SERVICE BULLETIN

Date	22/03/01
Document n°	FRN - SB2001-01 - Oven commutator
Last Doc. n°	-----
Brand	Smeg
Appliances involved	Built-in ovens : SE108X/1, SA392EB/1, SE392MFB1, SE392MF/1
Parts code	-----

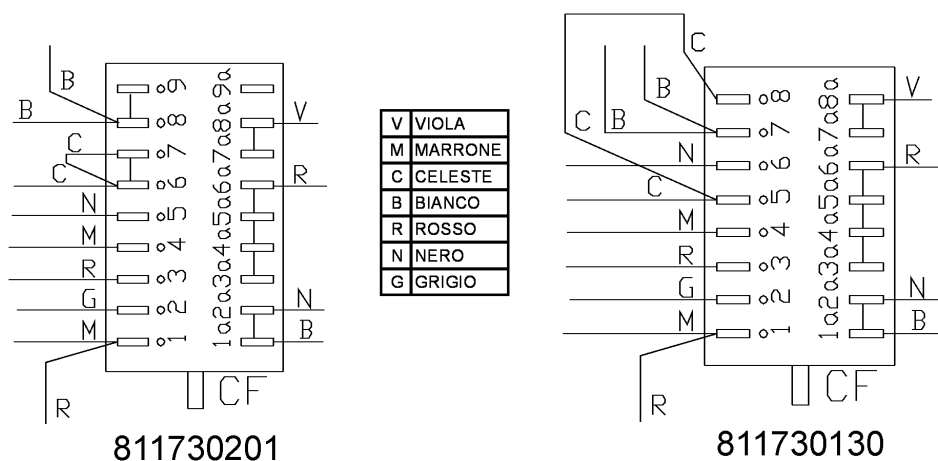
Problem	-----
Cause	-----
Modification description	For the above mentioned models the commutator code 811730130 has been superseded by the code 811730201, for few serial numbers. See the drawing below for the wiring connection.
Solution	-----
Date of introduction	The code 811730201 has been fitted on the oven SE108X/1: from serial number 07109317 to 07109416 SA392EB/1: from s.n. 08102323 to 08102372 SE392MFB1: from s.n. 08111417 to 08111466 from s.n. 11117118 to 11117166 SE392MF/1: from s.n. 11117168 to 11117201
Interchangeability	There is interchangeability.
